# MANDATORY SERVICE BULLETIN

**EFFECTIVITY:** BELL 407 MODEL HELICOPTERS EQUIPPED WITH AIRFILM  
CAMERA SYSTEMS G1 UTILITY MOUNT

**SUBJECT:** MANDATORY INSPECTION AND MODIFICATION OF NOSE  
CONSOLE AT G1 MOUNT FASTENERS

**DATE:** 10/20/2014

*Figure 1 G1 Mount Fastener Locations*

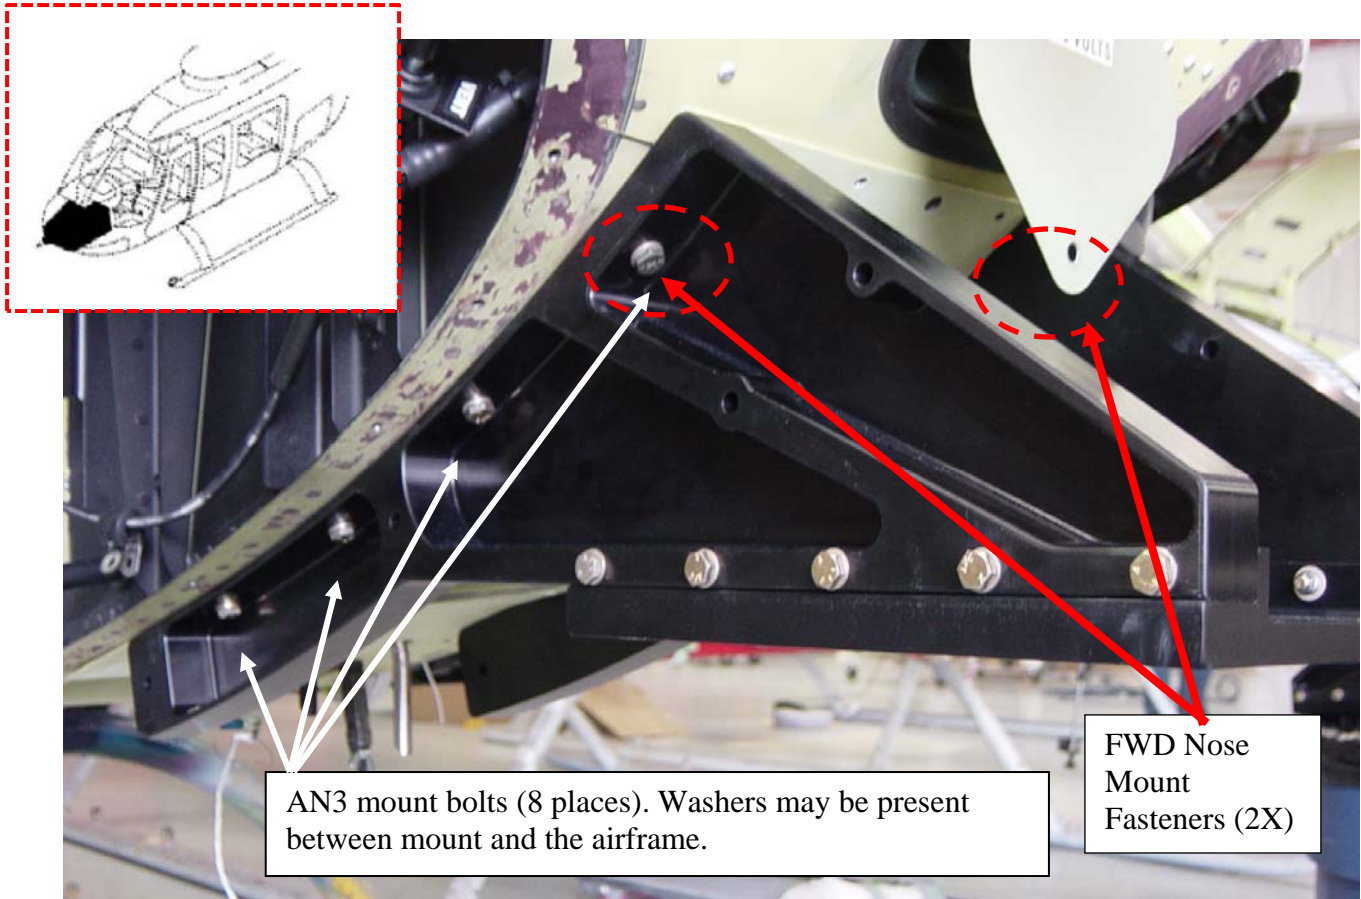
- (1) Remove G1-1 Utility Mount to gain access to the Internal Nose Console (airframe) by removing the 8 AN3 mounting bolts on the outboard upper flanges of the G1 Mount. Reference Install Instruction (AF-G1-006) for detailed description of removal procedures.

Washers may be present as shims between G1 mount and airframe. Note the location and quantity of the shims for reinstallation.

*Figure 2 View (looking Down) Showing the LH Side Forward Fastener with Crack Damage*

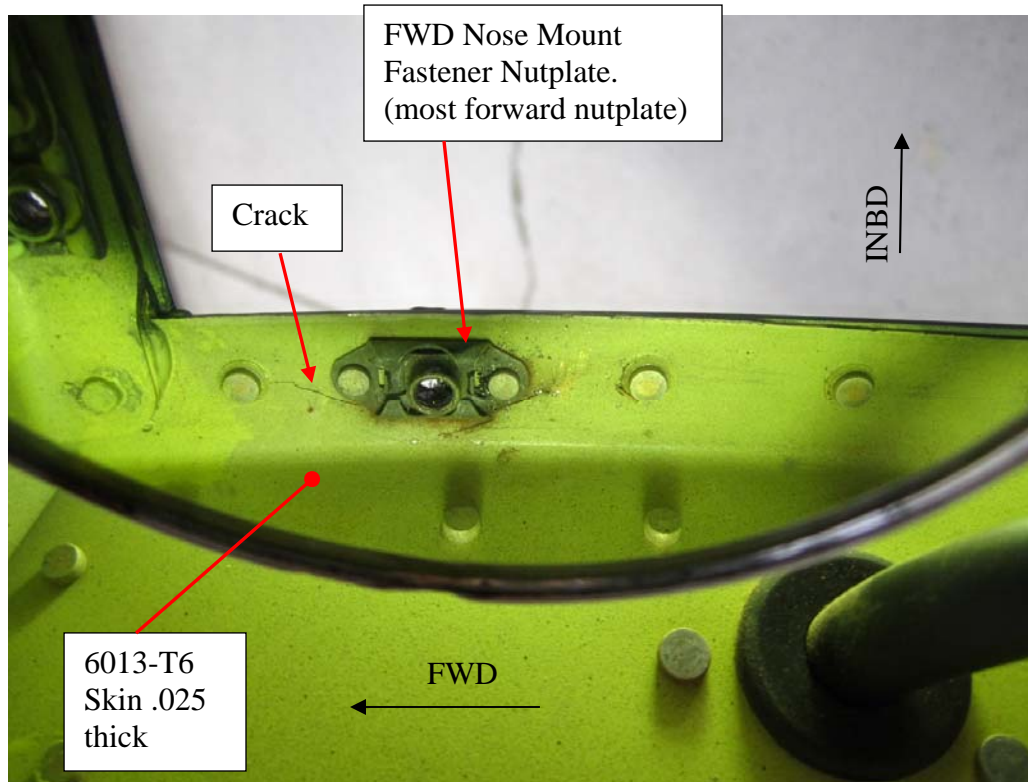
- (3) Inspect for cracks in the Nose Console area at the G1 mount forward fastener nutplates (RH & LH sides). Figure 3 shows a typical crack near the nutplate at the radius of the formed flange.

Use 10X magnified visual inspection or fluorescent penetrant inspection (per ASTM E1417) to inspect for cracks in the areas noted.

- (4) If no cracks are found, proceed to step 5. If cracks are present, repair in accordance with Airfilm Drawing AF-G1-100.

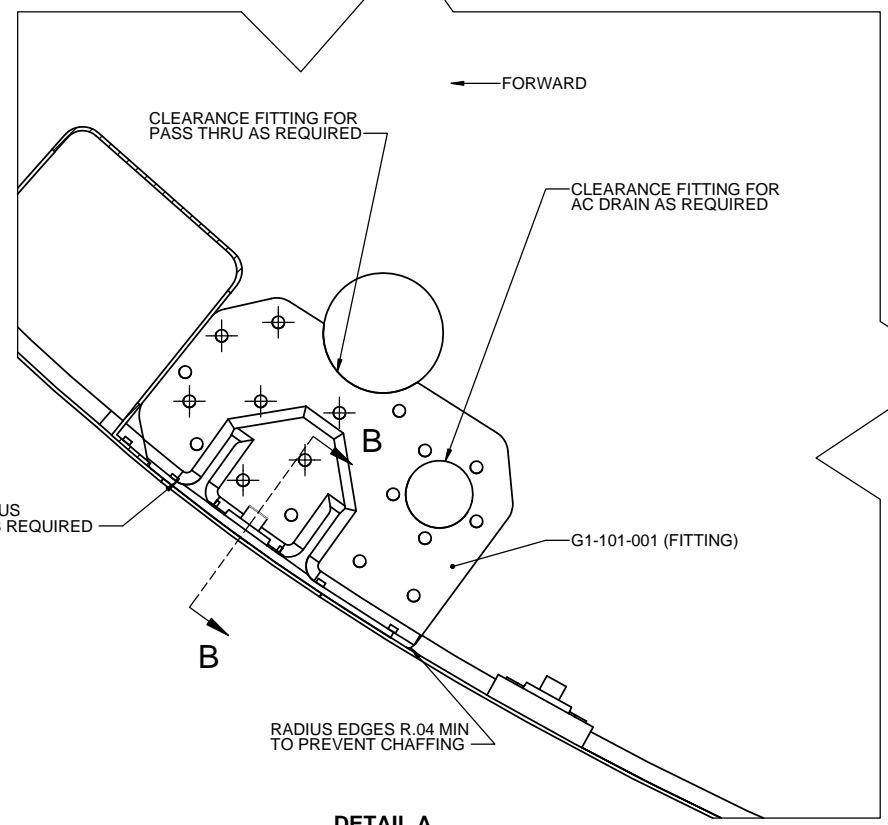
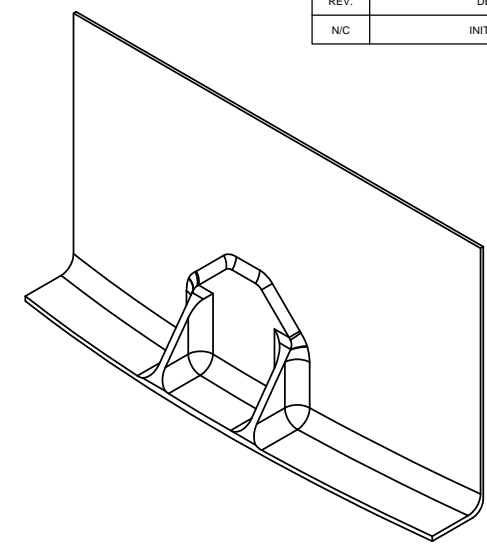
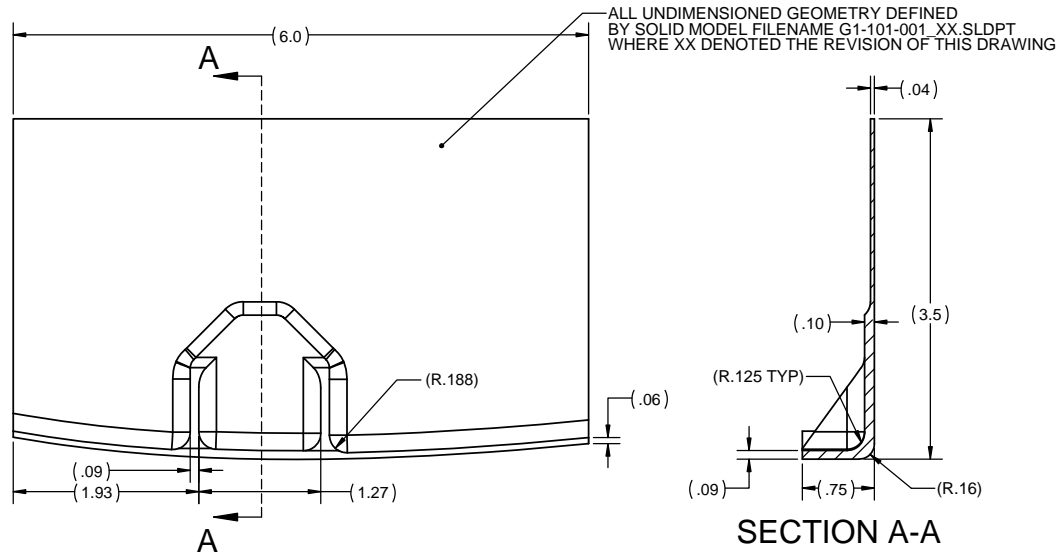
REV.	DESCRIPTION	DATE	APPROVED
N/C	INITIAL RELEASE	10/20/2014	SPH
A	REVISED NOTE 8 TO INCLUDE ALTERNATE RIVET CR3213-4 (BLIND RIVET)	12/1/2015	SPH

- USE FITTING TEMPLATE (G1-101-003) TO LAYOUT FITTING PROFILE GIVEN EXISTING FEATURES & HOLE LOCATIONS. TRIM FITTING AS REQUIRED TO CAPTURE THE REQUIRED NUMBER OF FASTENERS AND MAINTAIN 2D EDGE DISTANCE ON ALL FEATURES.
- LAYOUT NEW FASTENERS APPROX AS SHOWN ⊗. MAINTAIN A MINIMUM OF 2D EDGE DISTANCE ON ALL FEATURES. MINIMUM 6 FASTENERS ON EITHER SIDE OF FORWARD MOUNT FASTENER.
- DRY FIT FITTING.
- MATCH DRILL FASTENER HOLES INTO FITTING AND SKIN.
- DEBURR ALL HOLES.
- TREAT EFFECTED AIRFRAME AND NEW COMPONENTS FOR CORROSION PREVENTION IAW BTH-ALL-SPM.
- INSTALL FITTING AND RIVETS WET WITH CORROSION INHIBITING SEALANT (P/S 890 OR EQUIVALENT).
- USE MS20426AD4 RIVETS FOR FLUSH INSTALLATION ON THE EXTERIOR AND MS20470AD4 (OR CR3213-4) RIVETS IN WEB.
